Our ref: 1CP01-MDS_ARP-TP-NOT-SS08_SL23-990023

Redevelopment of the site to include change of use of former school building to office use with associated external alterations and multi-use community facilities; erection of a two storey Construction Skills Centre and provision of public open space together with alterations to existing access arrangements, all as meanwhile uses for a period of 10 years (planning application ref: 2019/3091/P as amended by 2023/4110/P)

This application is made under Section 73 of the Town and Country Planning Act 1990, and seeks to vary conditions 3 and 9 applied to the approved planning permission for the redevelopment and change of use of the former Maria Fidelis school building (planning application ref: 2019/3091/P as amended by 2023/4110/P).

Figure 1: Diagram showing intended ground floor occupiers and uses

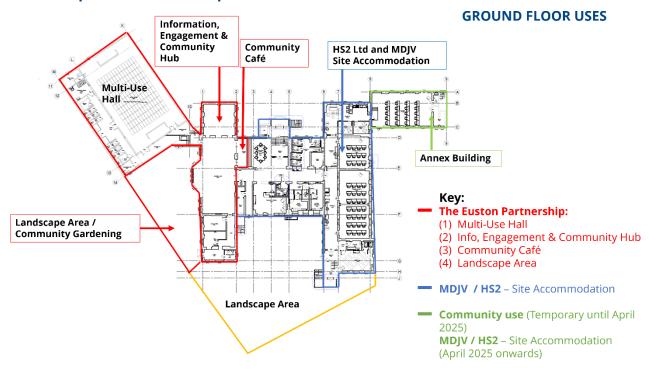
The various uses on the site will now be operated by different entities, working in collaboration. Figure 1 shows the intended split of occupiers and uses across the ground floor of the site. It is now intended that HS2 Ltd, MDJV and its supply chain will occupy the office spaces in the main building as part of the management of the HS2 Euston station site and the wider HS2 project. The offices will be used for collaborative working between HS2 and its partners. MDJV will have overall responsibility for the site.

Community uses on the site will be facilitated in part by The Euston Partnership. The Euston Partnership's strategic aims for community use of the site are to support local communities to socialise, to provide employment and upskilling opportunities, and to support mental and physical wellbeing. The proposals for the Euston Partnership operated parts of the ground floor are as follows.

- Information, Engagement and Community Hub (Library, Exhibition Hall, Drop-In 'Clinic' and Office) the intention is for these spaces to be used flexibly to facilitate various community activities. Each space has specific characteristics to support the wide range of these activities. The Library space is intended to be a quieter area, used for activities such as out of school hours study support. The Exhibition Hall is intended to be used as a space for the community to socialise and to learn about what is happening in the area. The Drop-In 'Clinic' space will act as a private interview room supporting individual and small group community activities, such as employability coaching and social prescribing. The Office will be used by local voluntary and community sector groups to support their running of community programmes. The hub will also enable HS2 to meet its commitments under the HS2 Act to provide a local information drop-in centre (U&A no. 2285). The hub will be in place for the duration of the meanwhile uses planning permission and managed by The Euston Partnership.

- Multi-Use Hall this space will mainly be used for community sports and leisure
 activities. Examples of this could include physical social prescribing activities by
 Green Light Pharmacy and physical activity programmes by Fitzrovia Youth In
 Action and the Camden Community Sports/Physical Activity Team. The space may
 also potentially be used by Shahjalal Jame Masjid (Euston Mosque) for prayers. The
 multi-use hall will be in place for the duration of the meanwhile uses planning
 permission and managed by The Euston Partnership.

- Community Café this café will not be a commercial operation and will operate primarily as a community run social enterprise, training young people to work as baristas and in the hospitality industry. There will be no primary food preparation on site, and the café's kitchen will be to an office kitchen specification. The café would serve light refreshments to service users and visitors to the old school building, operating for six hours a day Monday to Friday (expected to be 9am-3pm). The café's kitchen would be used by office staff outside these hours. The community café will be in place for the duration of the meanwhile uses planning permission and managed by The Euston Partnership.
